10/657,934

Barry Wixey

Office Action Summary	Application No.	Applicant(s)	
	10/657,934	WIXEY ET AL.	
	Examiner	Art Unit	
	Shelley Self	3725

DETAILED ACTION

FIG. 1

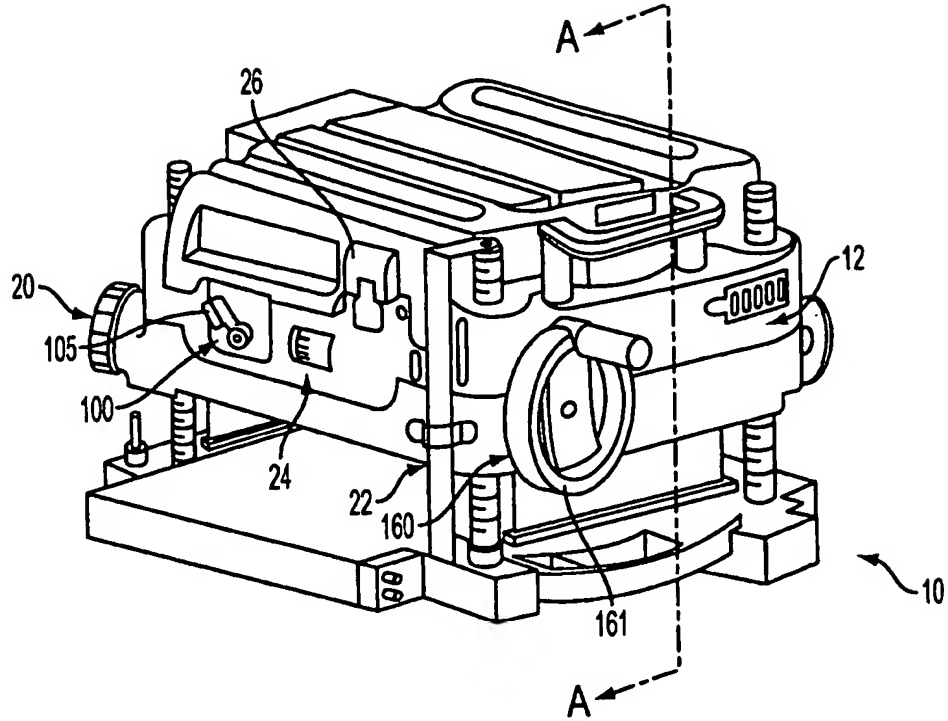
With regard to claim 4, Welsh discloses a carriage height mechanism (106, 108) disposed on the carriage assembly and disposed on the front half of the power planer (fig. 1).

FIG. 2

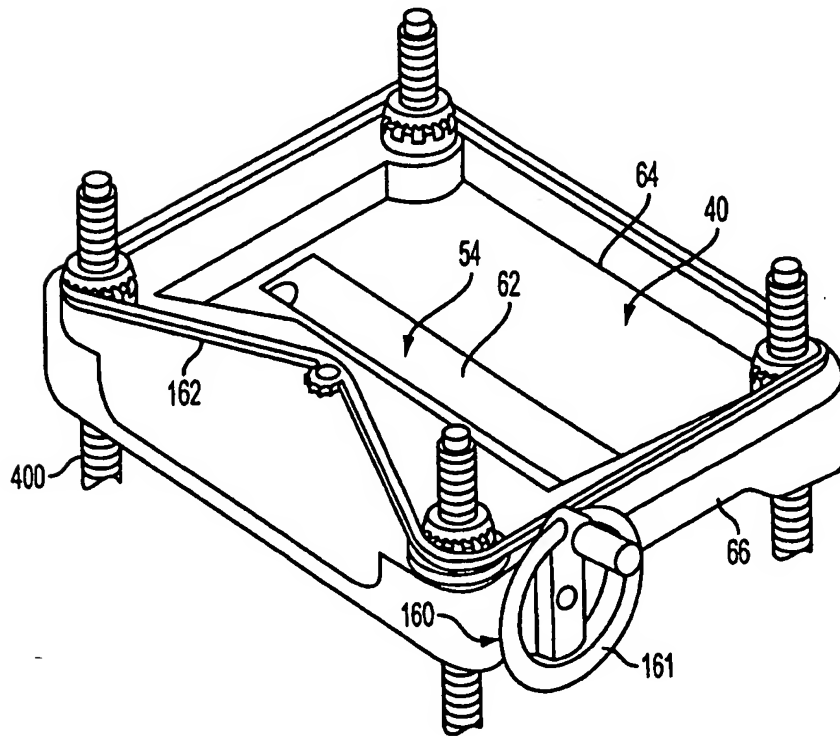
With regard to claims 11 and 13, Welsh discloses the first and second rollers (76) drivingly connected to the transmission via a chain (80; fig. 2; col. 6, lines 11-12).

With regard to claims 12 and 14, Welsh discloses a chain tensioner mechanism (fig. 2) for maintaining constant tension on the chain (fig. 2).

Further regarding claim 15, as noted above with reference to claim 1, Welsh further discloses first, second, third and fourth springs (fig. 2). Welsh is silent to the spring forces, however it is inherent that Welsh's first and third springs provide unequal force because as a workpiece is initially gripped and feed into the planer apparatus via the first feed roller the first and second springs provide equal forces to maintain the workpiece level and straight. As material is removed from the workpiece and the workpiece is continually feed through the planer the second roller grips the workpiece and pulls the workpiece through the planer device. Because less material is ejected out of the planer than initially put it, i.e. material has been removed via the carriage assembly and cutterhead, less force is necessary to grip and pull the work piece. Accordingly the springs that provide the force to the feed rollers (76) have differing spring forces. As to the optimal selection of the spring forces, Welsh is silent, however
